CS Memorandum No. 1698

Subject: Configuration Management Board Meeting No. 169

CMB Meeting Minutes #169

SUBJECT: Configuration Management Board Meeting # 169 – Rev. No. 0

AS BUILT - UMS SOUTH BATTERED TANGENT PILES

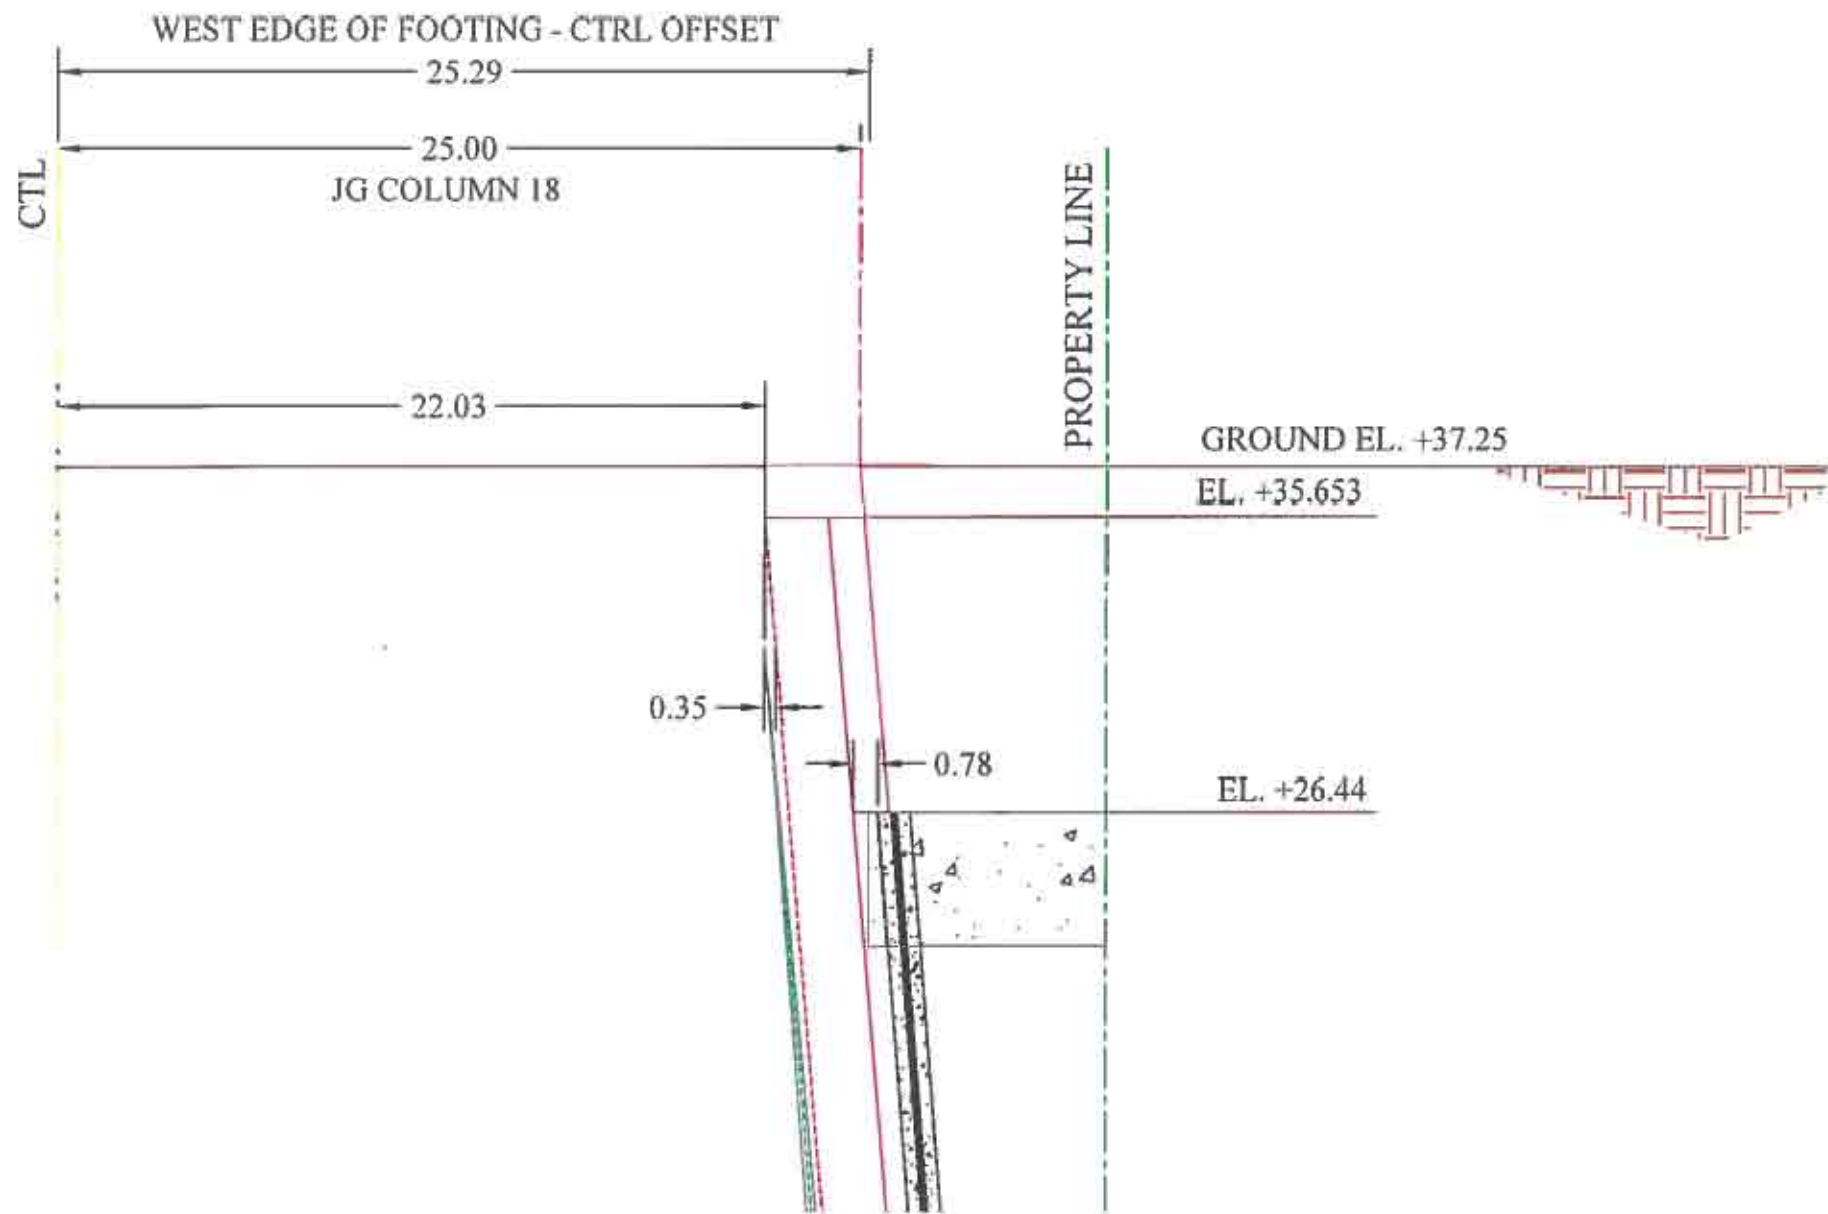
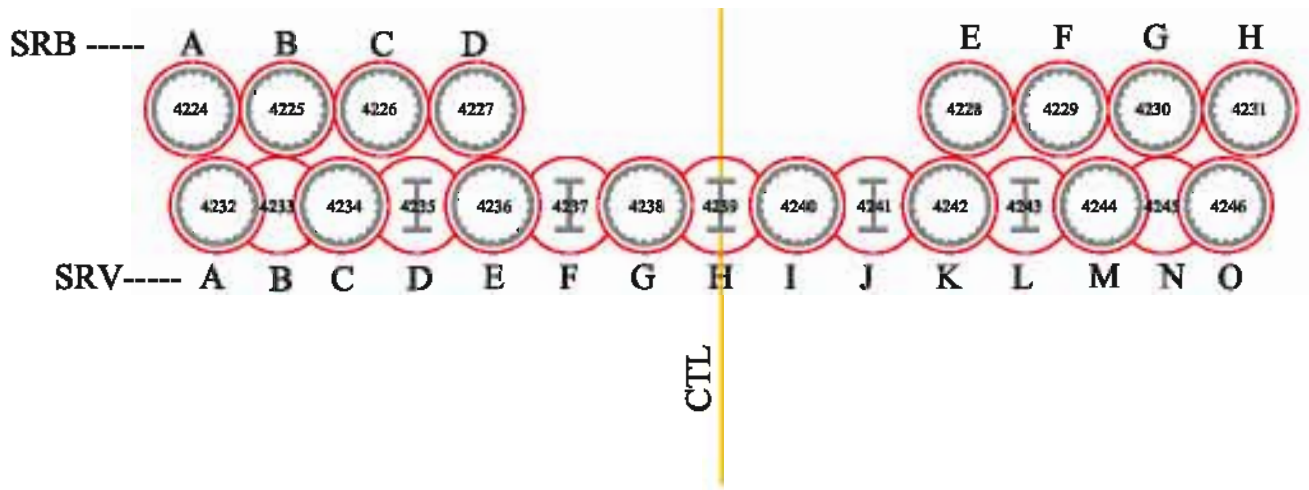
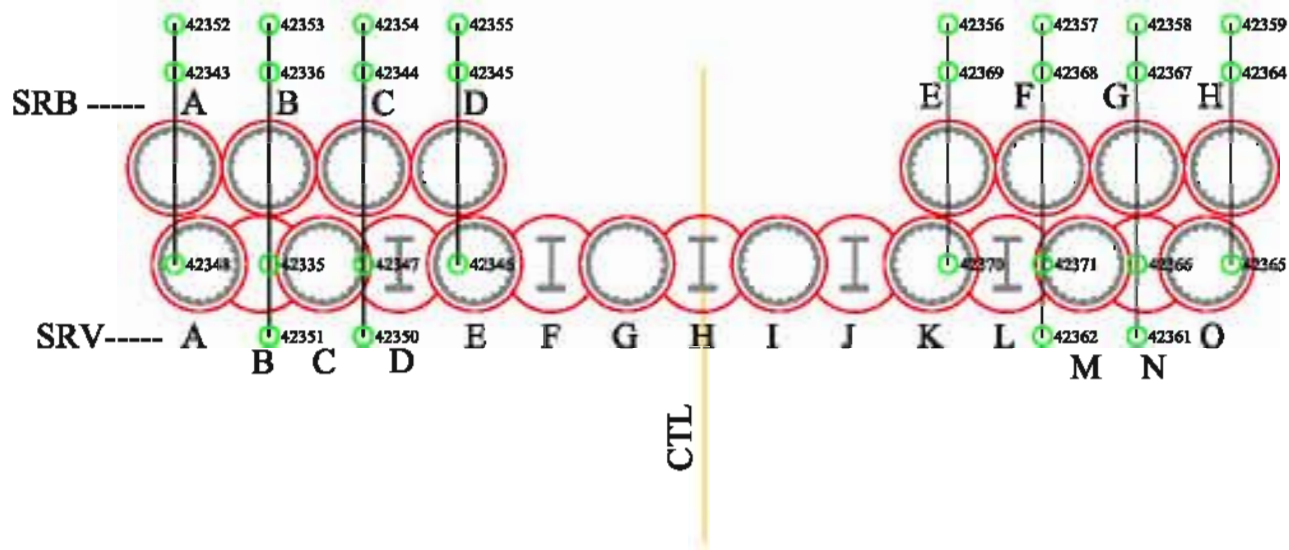
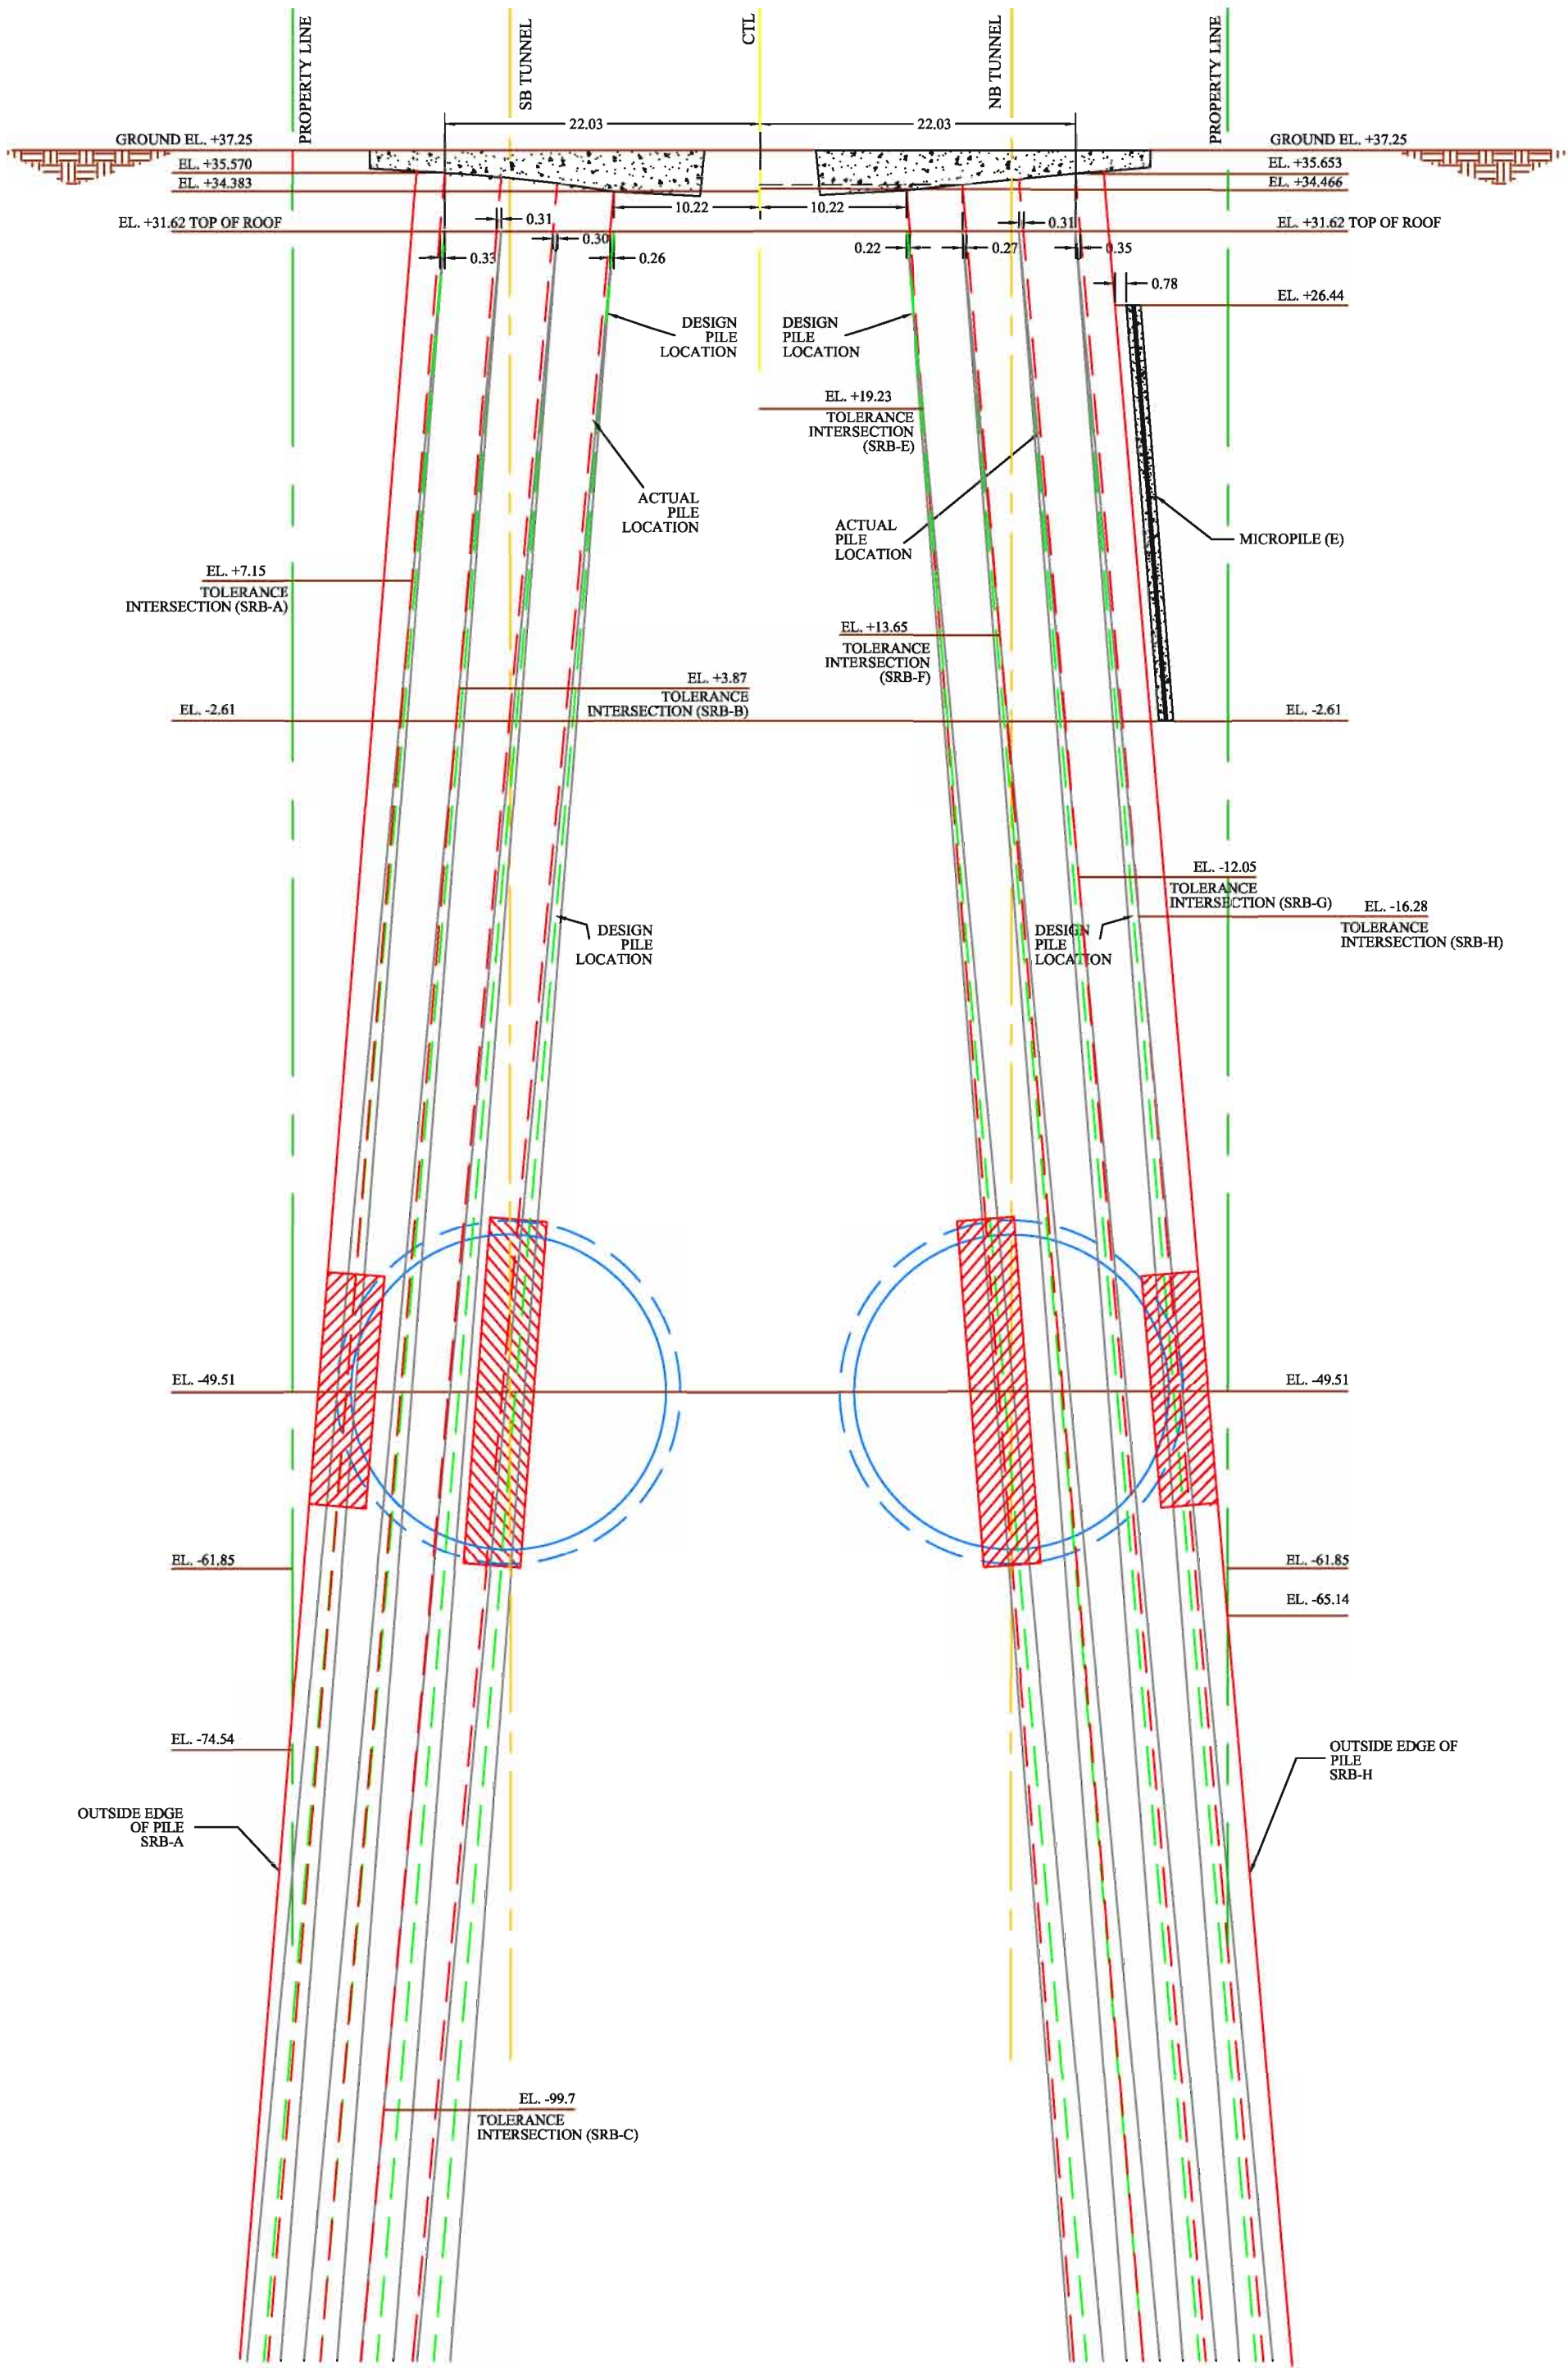
The Contractor then moved the drill to a third location 4 inches to the east (proposed and accepted via RFI 278), between SRB-H and SRV-O. Jet grout column 18 was installed successfully at this location.

Based on the 1251 as-builts, it was expected that between 6 and 12 inches of clearance would be available between the secondary closure wall footing (micropile cap) and the future UMS Station tangent piles. At the base of the micropile, 4-3/4 inches of clearance were expected. The Contractor was required to install an inclined jet grout column in between tangent pile SRB-H and the 1251 installed micropiles. The drill bit for jet grout columns was 8-inches in diameter. We note that SRB-H was installed approximately 4-inches too far east (at the top of the tangent pile) of the planned location due to a survey error (refer to 1252 NCR 36). However, this does not change the fact there was insufficient clearance to install the inclined jet grout column.

- 6. METHOD USED TO OVERCOME OBSTRUCTION
- The Contractor moved the drill location for Jet Grout Column 18 south 18 inches. The same obstruction was again encountered at the same depth (10 feet below ground surface).
- The Contractor then moved the drill to a third location 4 inches to the east (proposed and accepted via RFI 278), between SRB-H and SRV-O. Jet grout column 18 was installed successfully at this location.
